HADDAM NECK PLANT

PROPOSED CHANGES TO TECHNICAL SPECIFICATIONS

JULY, 1980

FIGURE 5.2-1 Chart of Organizational Responsibilities for Northeast Utilities and the Connecticut Yankee Atomic Power Company.

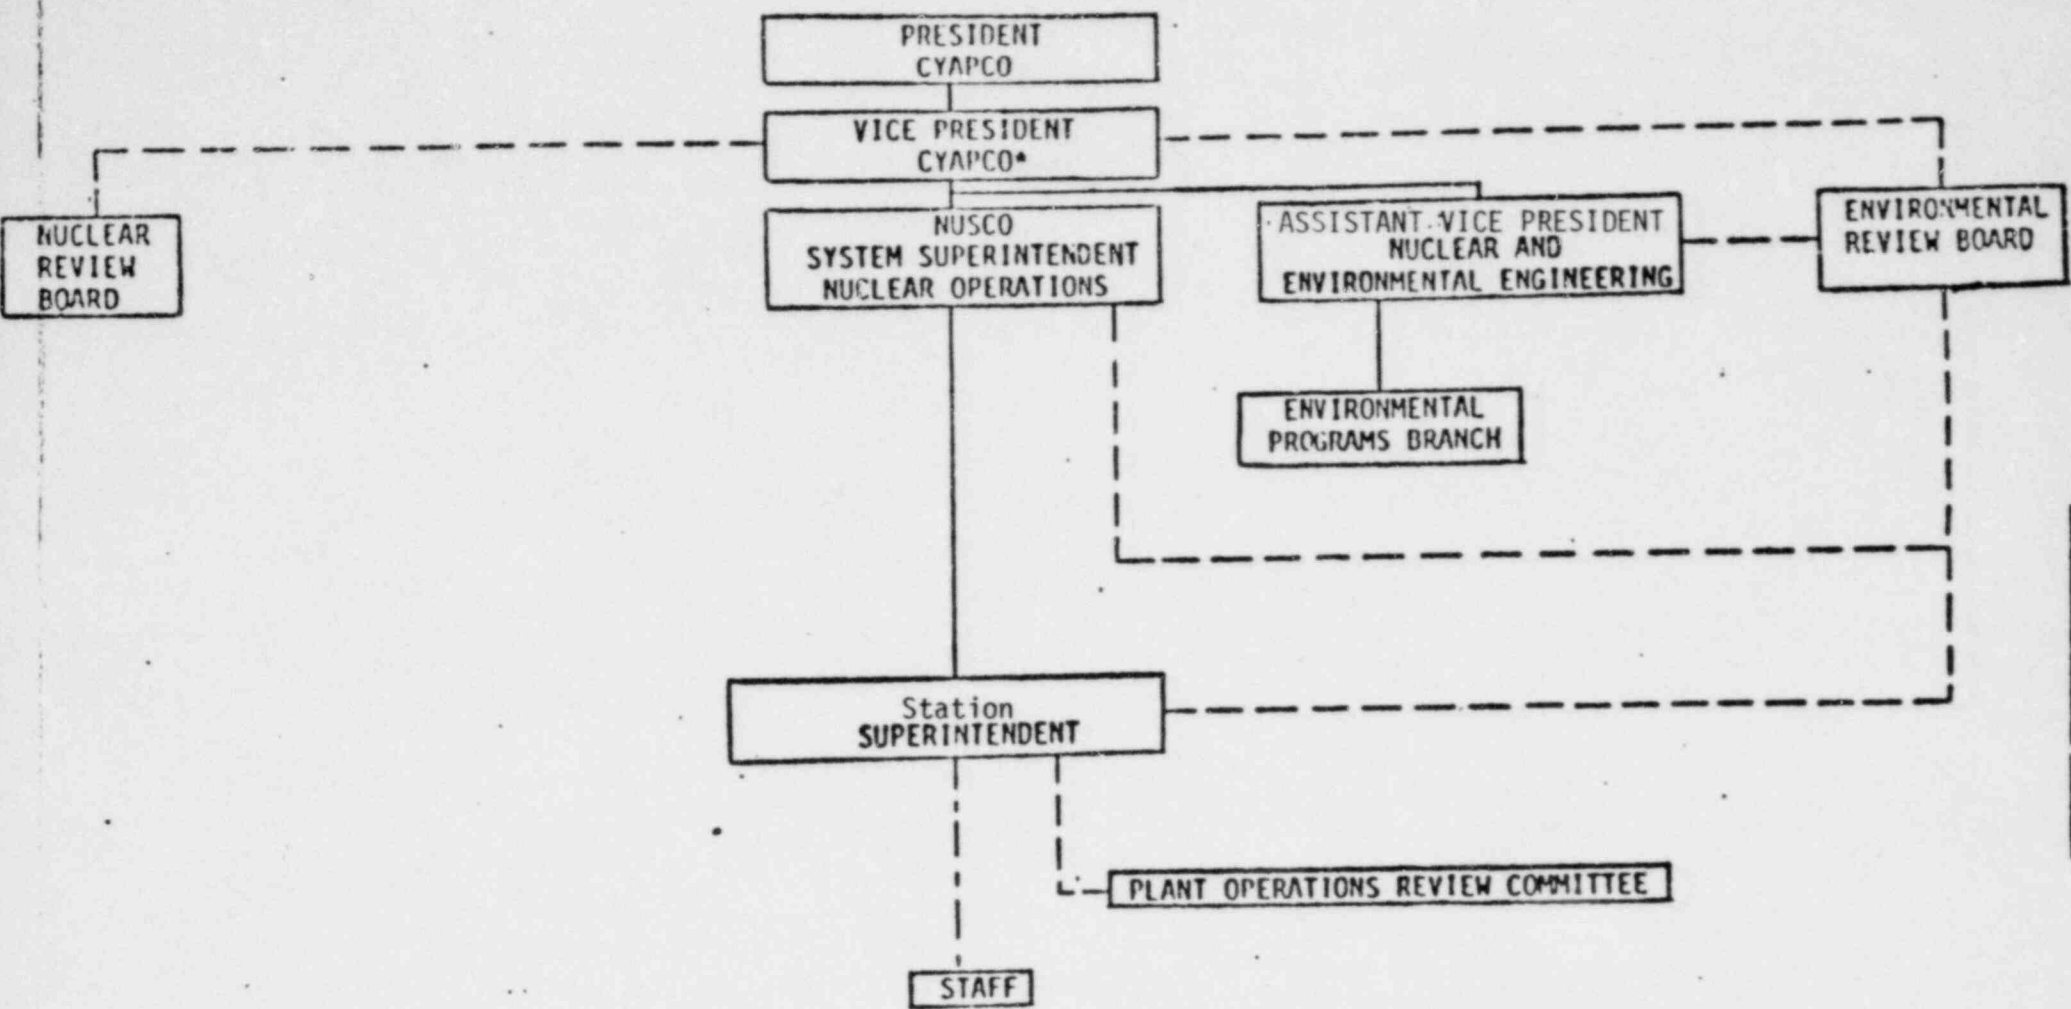
The ERB shall be advisory to the NUSCO Senior Vice President Nuclear Engineering and Operations, the Station Superintendent, the NUSCO System Superintendent Nuclear Operations and the NUSCO Assistant Vice President Nuclear and Environmental Engineering as indicated in Figure 5.2-1.
